MR-1614F

Application	General Data	
Project Name: College Park Academy and Two R&D Flex Buildings Location: 5751 Rivertech Court and 6501 Lafayette Avenue Riverdale Park, MD 20737 Applicant/Address: University of Maryland 0128 Main Administration Building College Park, MD 20742	Planning Board Hearing Date:	7/28/16
	Date Accepted:	6/6/16
	Mandatory Action Timeframe:	60-Day Review
	Acreage:	14.92
	Zone:	M-U-I
	Planning Area:	68
	General Plan Designation:	Established/Community
	Council District:	District 3
	Municipality:	Riverdale Park

MR-1614F Staff Report – College Park Academy Charter School and Two R&D Flex Buildings Project

SUBJECT: Mandatory Referral MR-1614F
University of Maryland College Park Academy Charter School
Lots 2

COLLEGE PARK ACADEMY SITE LAYOUT

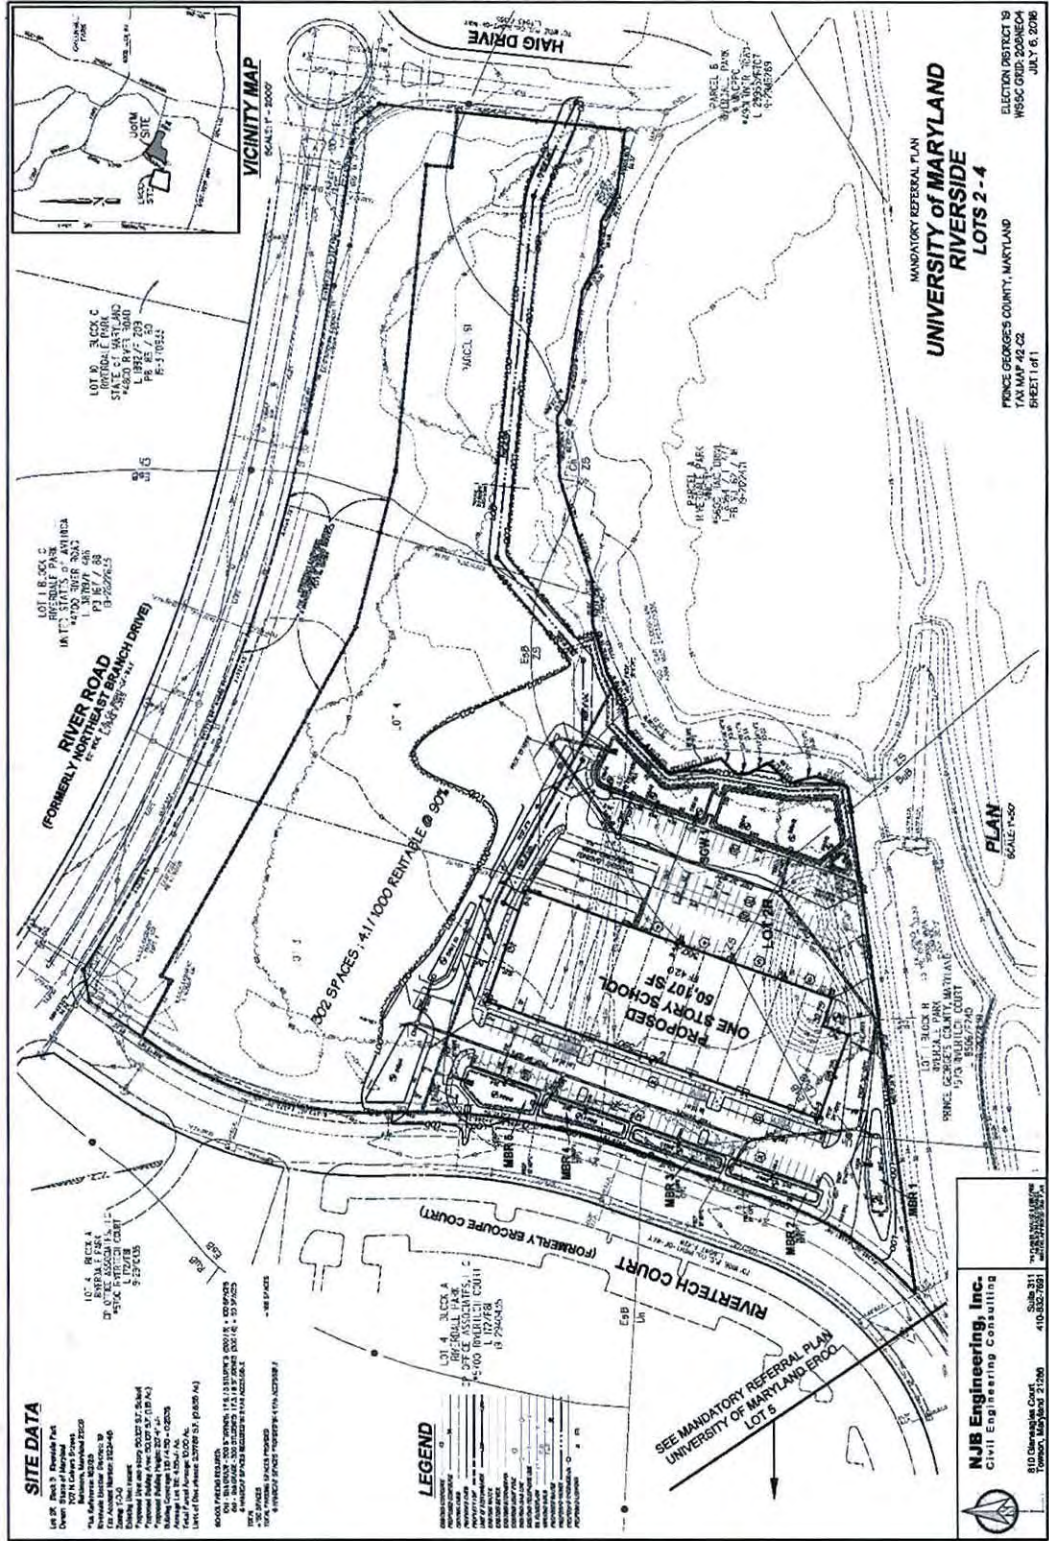
- ❖ The applicant is encouraged to revise the plans to provide a gable roof over the one-story building.

- ❖ The applicant is encouraged to incorporate additional green area on the site by removing parking at the rear of the building that directly abuts the rear façade, provide foundation plantings, a sidewalk (running parallel to the face of the building), and a six foot wide planting area between the sidewalk and the drive aisle in which shade trees can be planted to provide for full pedestrian connectivity to all sides of the building and all entrances.

- ❖ The applicant is encouraged to revise the plans to provide a fenced multi-purpose court on-site that is adequately protected from vehicular parking and circulation. In addition, shade trees should be installed to provide relief from the sun.

- ❖ The applicant is encouraged to revise the plans to provide additional green area on the site for an outdoor gathering area for students at the drop-off and pick-up area of the site.

- ❖ Signage should be limited to the nine foot nine inch high by ten foot wide freestanding sign proposed for the school on Lot 2.
